**SERVICE BULLETIN**

**N° 189-316**

**ATA 93 - FLIR 380 HDC REMOVABLE PARTS INSTALLATION**

This Service Bulletin is issued in order to provide the necessary instruction on how to complete the installation of Kit FLIR 380 HDc P/N 8G9350F00611.

**Figure 5**

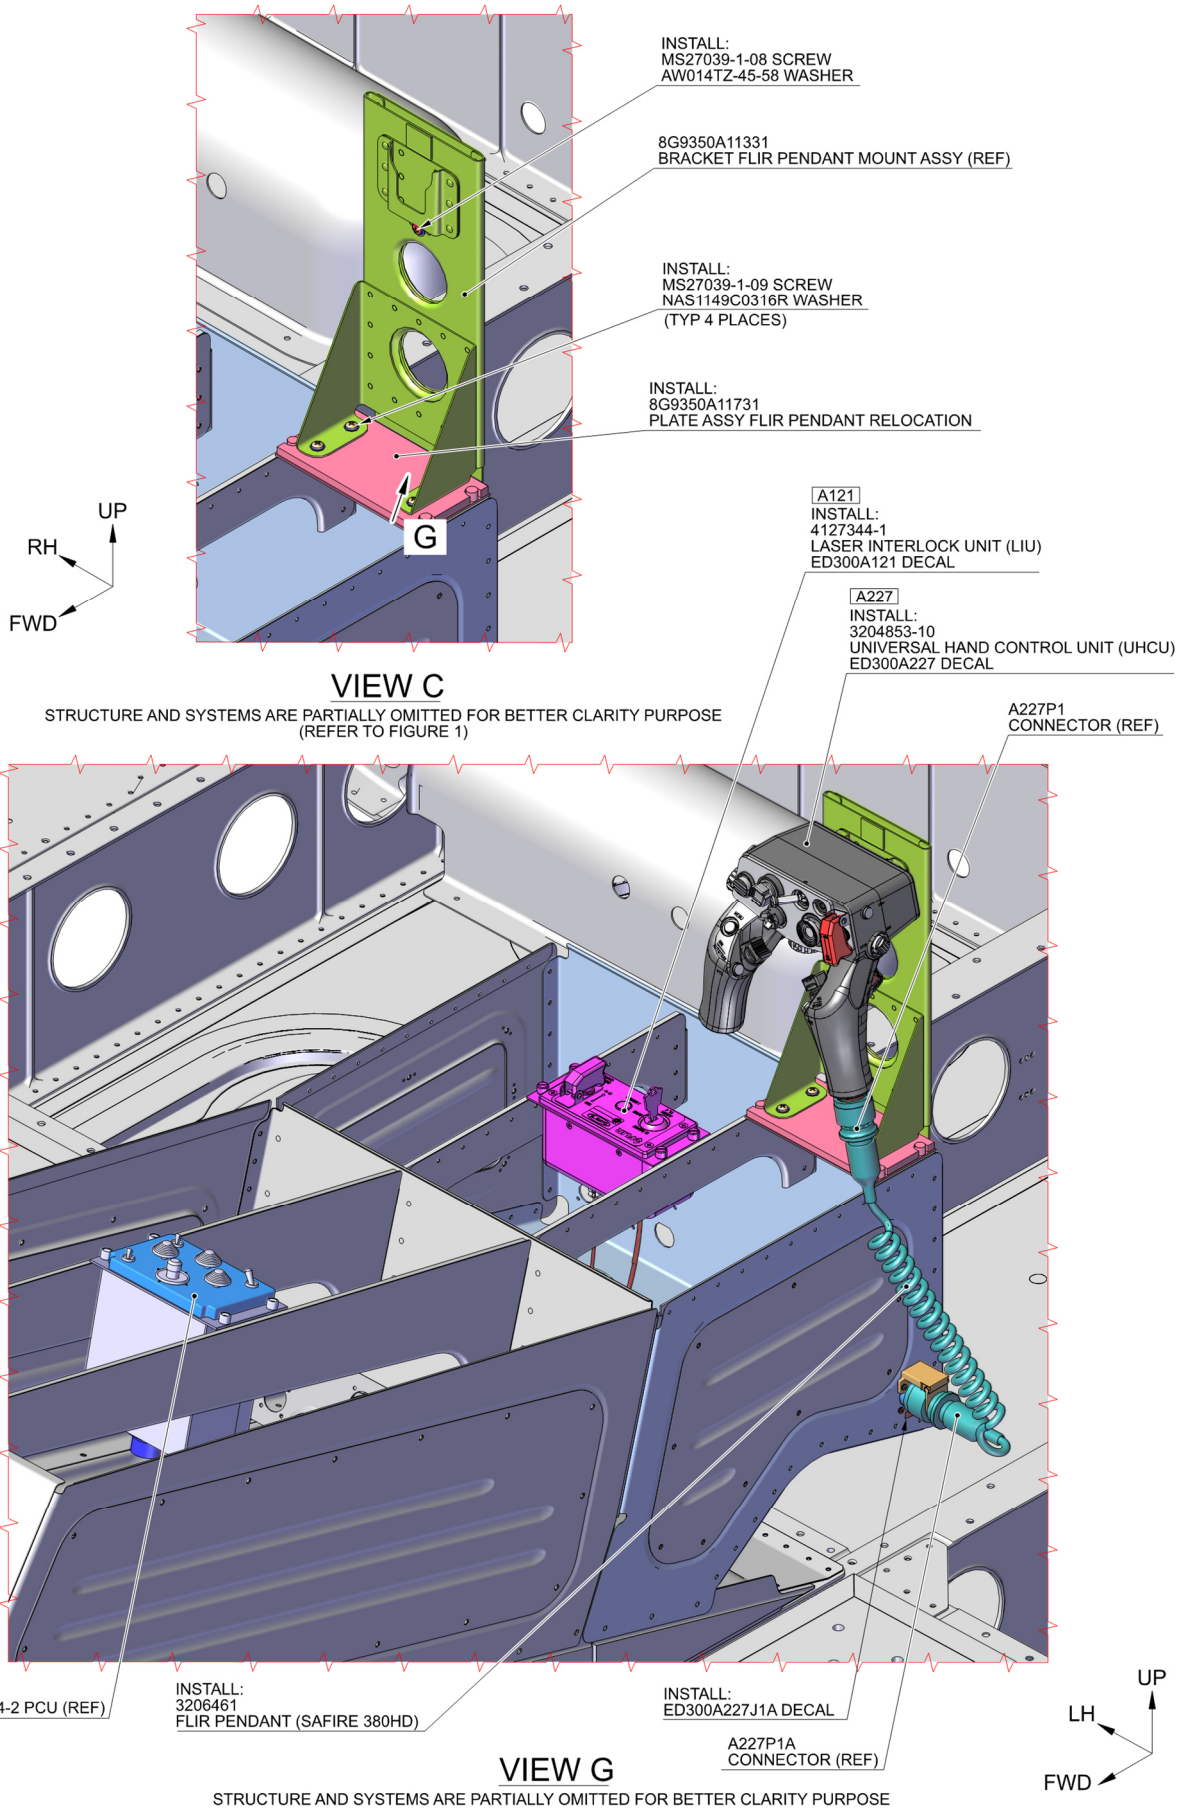
- 5.6.7 With reference to Figure 5 View C, install the plate assy FLIR pendant relocation P/N 8G9350A11731 on the interseat console extension by means of its captive screws.

- 5.6.10 With reference to Figure 5 View C, fix the bracket FLIR pendant mount assy P/N 8G9350A11331 to the plate assy FLIR pendant relocation P/N 8G9350A11731 by means of n°4 screws P/N MS27039-1-09 and n°4 washers P/N NAS1149C0316R.

- 5.6.11 With reference to Figure 5 View C, install the screw P/N MS27039-1-08 and the washer P/N AW014TZ-45-58 on the bracket FLIR pendant mount assy P/N 8G9350A11331.

- P/N NAS1802-04-7 (previously removed) and n°4 washers P/N NAS620-4L (previously removed).
- 5.7.5 In accordance with AMP DM 89-A-11-00-01-00A-720A-A and with reference to Figure 5 View G, install the decal P/N ED300A227J1A near the connector A227J1A.

- 5.7.6 With reference to Figure 5 View G, install the universal hand control unit (A227) (UHCU) P/N 3204853-10 on the bracket FLIR pendant mount assy P/N 8G9350A11331.

- 5.7.7 With reference to Figure 5 View G, install the FLIR pendant (Safire 380HD) P/N 3206461 and connect the connector A227P1A to the connector A227J1A and the connector A227P1 to the UHCU (A227).

- 6.2.1 With reference to Figure 5 View G, install the laser interlock unit (LIU) (A121) P/N 4127344-1 in its position on the interseat console extension by means of its four captive screws. Perform electrical connections of the connector A121P2 (C/A A1A446) and the connector A121P3 (C/A A1A445) to the LIU (A121).

- 6.2.2 In accordance with AMP DM 89-A-11-00-01-00A-720A-A and with reference to Figure 5 View G, install the decal P/N ED300A121 on the structure of the interseat console in an area adjacent the LIU (A121).

**Figure 6**

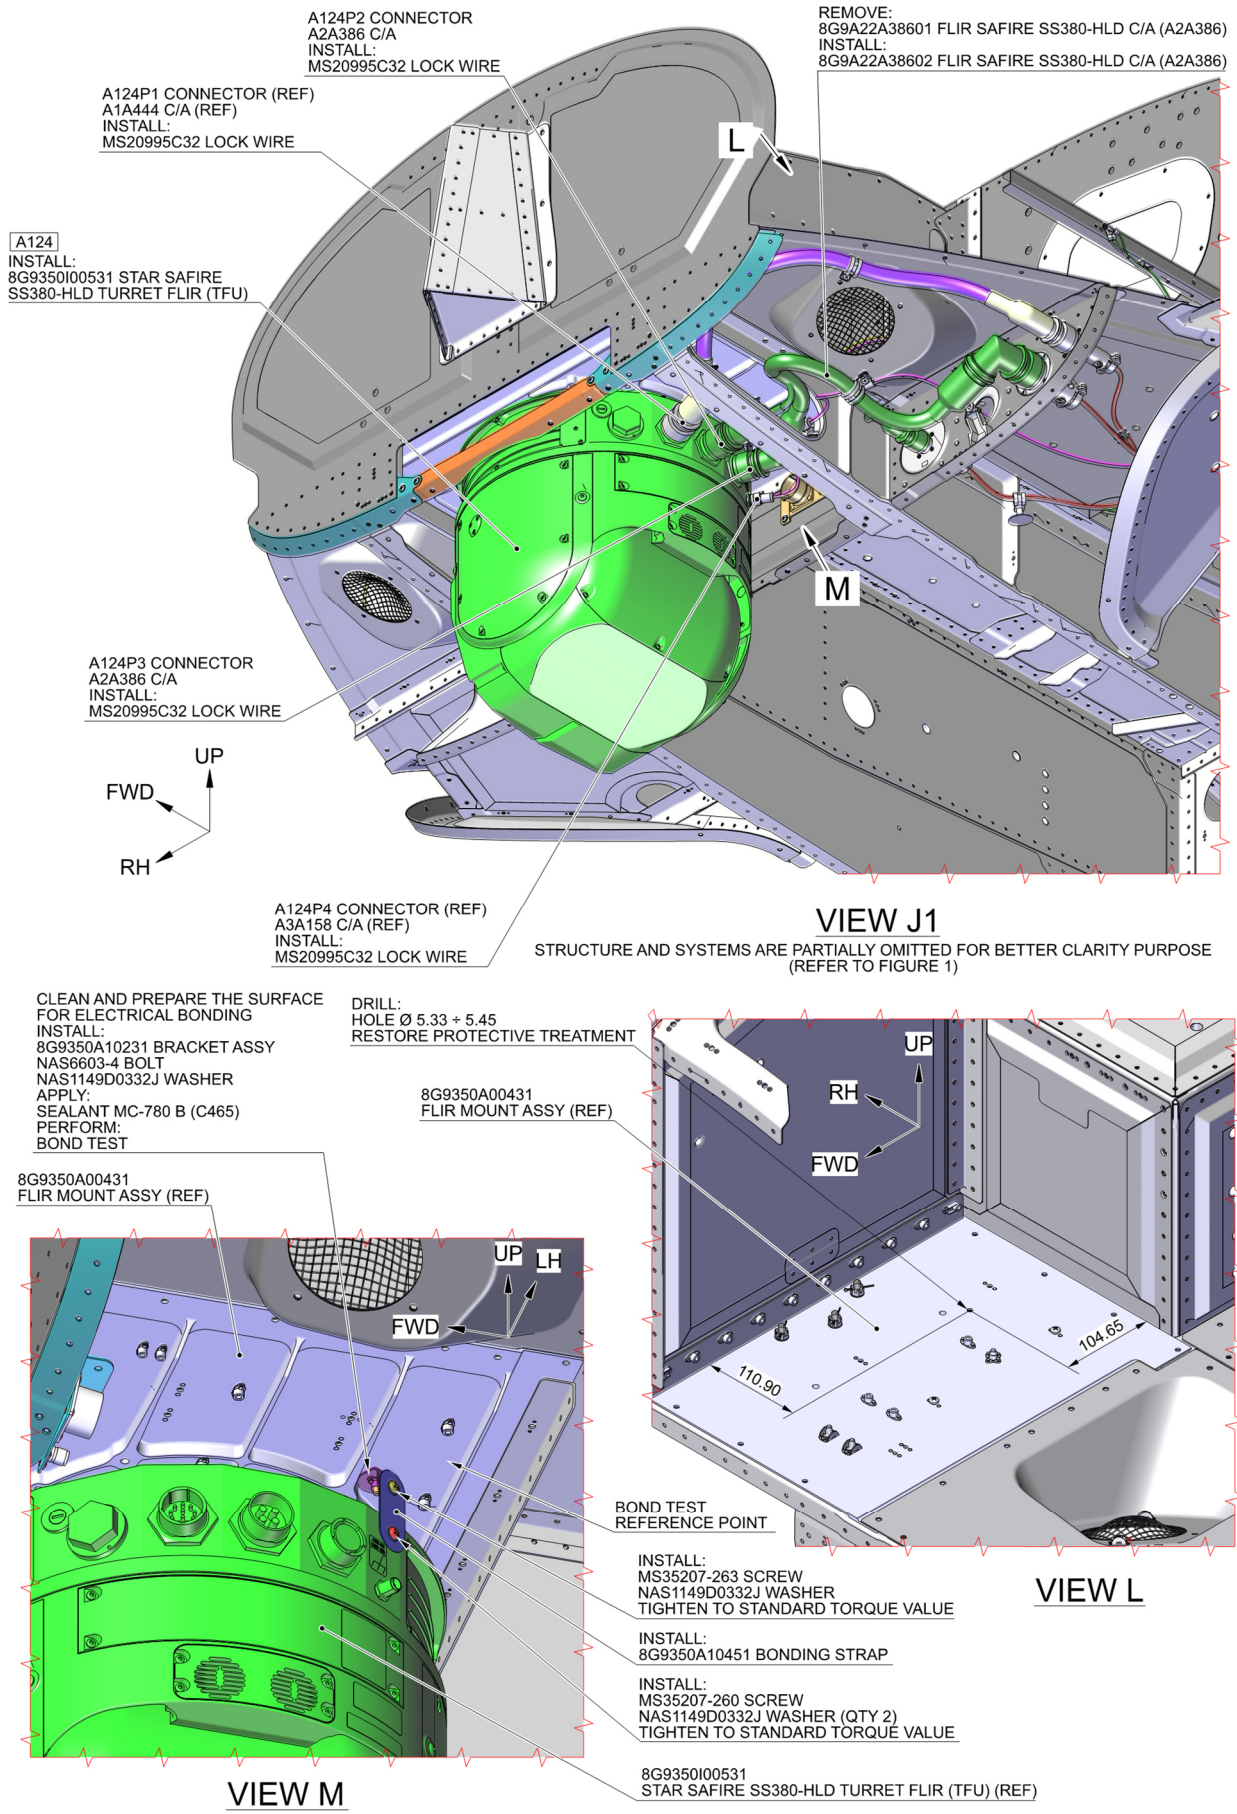
- 3.1 With reference to Figure 6 View J1, remove the FLIR Safire SS380-HLD

- 3.2 With reference to Figure 6 View J1 and Figure 7 View J2, lay down the new FLIR Safire SS380-HLD C/A (A2A386) P/N 8G9A22A38602 on the existing route. Secure the cable assy by means of existing hardware and lacing cords as required.

- 4.1 With reference to Figure 6 View L and View M, drill the hole  $\varnothing 5.33 \div 5.45$  thru the FLIR mount assy P/N 8G9350A00431 in accordance with the dimensions shown. Restore the protective treatment of any cut-out edges.

- 4.2 With reference to Figure 6 View M, temporarily locate the bracket assy P/N 8G9350A10231 on the FLIR mount assy P/N 8G9350A00431. Clean and prepare the surface for electrical bonding.

- 4.3 With reference to Figure 6 View M, install the bracket assy P/N 8G9350A10231 under the FLIR mount assy P/N 8G9350A00431 by means of the bolt P/N NAS6603-4 and the washer P/N NAS1149D0332J. Apply a fillet of sealant MC-780 B (C465) around the bracket assy P/N 8G9350A10231.

- 4.4 Perform the bonding test by means of the test meter “Thorn-EMI BT51” in the indicated position.
5. In accordance with AMP DM 89-A-06-41-00-00A-010A-A and with reference to Figures 1 thru 5, remove all external panels, internal panels and internal liners as required to gain access to the area affected by the installation and perform FLIR HDC pendant in cockpit relocation P/N 8G9350P01111 as described in the following procedure:

- 6.3.6 In accordance with AMP DM 89-A-20-00-00-00A-711A-A and with reference to Figure 6 View M, tighten the two screws to the standard torque value with an applicable torque wrench.

- 6.3.7 With reference to Figure 6 View J1, perform the electrical connections of the connectors A124P1 (C/A A1A444), A124P2 (C/A A2A386), A124P3 (C/A A2A386) and A124P4 (C/A A3A158) to the Star Safire SS380-HDC turret FLIR (TFU) P/N 8G9350I00531. Safety the connectors by means of lock wire P/N MS20995C32.

**Figure 7**

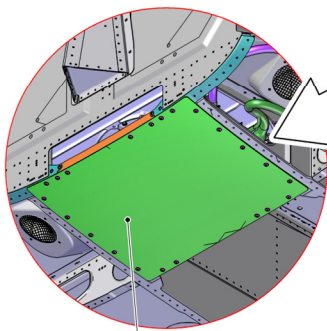
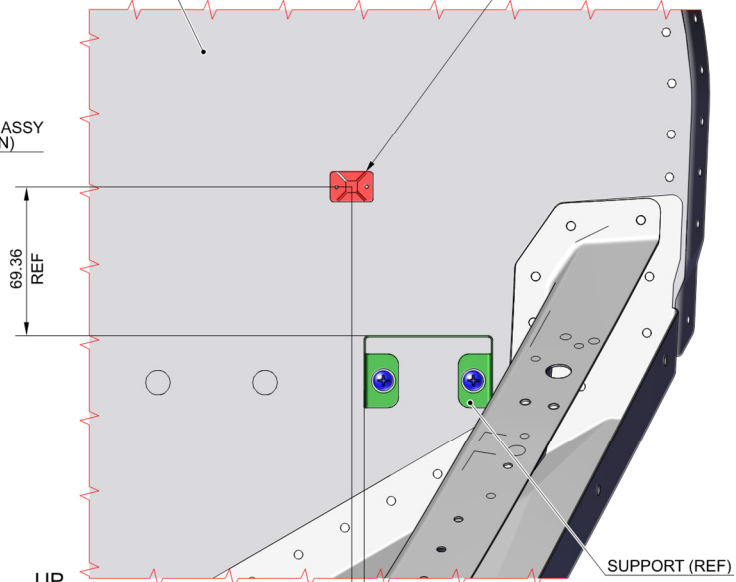
2. With reference to Figure 7 View J2, if present, remove the FWD lower panel assy P/N 8G5331P06031 and n°22 screws P/N A428A3C09. Retain screws for later reuse.

- 3.3 With reference to Figure 7 View J2, perform electrical connection of the connector P171 (C/A A2A386) to the connector J171.
- 3.4 With reference to Figure 7 View J2, perform electrical connection of the connector P173 (C/A A2A386) to the connector J173.

- 6.1 With reference to Figure 7, perform the FLIR Safire SS380 electrical replacement P/N 8G9350A11011 as described in the following procedure:
- 6.1.1 With reference to Figure 7 View K, if necessary, install the electrical support P/N AW001CL001-N6 on the structure STA1125 by means of the adhesive CB200-40 (C356) in accordance with the dimensions shown.

- 6.1.2 With reference to Figure 7 View K, perform electrical connection of the connector CP101P2 (C/A A3A158) to the splitter CP101.
- 6.2 With reference to Figures 2 and 5, perform the FLIR Safire SS380-HDC equipment instl P/N 8G9350A09711 as described in the following procedure:

- 6.4.1 With reference to Figure 7 View J2, install the lower panel RH P/N 8G9350P00451 and the lower panel LH P/N 8G9350P00531 by means of n°22 screws P/N A428A3C09 (if present, use existing screws removed at step 2). Protect all fasteners by means of the corrosion preventive compound Cor-Ban 27L (C075).

INSTALL:  
8G9350P00451 LOWER PANEL RH  
8G9350P00531 LOWER PANEL LH  
A428A3C09 SCREW (QTY 22)  
TIGHTEN TO STANDARD TORQUE VALUE  
APPLY:  
COR-BAN 27L (C075)

REMOVE (IF PRESENT):  
8G5331P06031 FWD LOWER PANEL ASSY  
A428A3C09 SCREW (QTY 22)(RETAIN)

CP101P2 CONNECTOR (REF)  
A3A158 C/A (REF)  
INSTALL (IF NECESSARY):  
AW001CL001-N6 SUPPORT  
APPLY:  
ADHESIVE CB200-40 (C356)
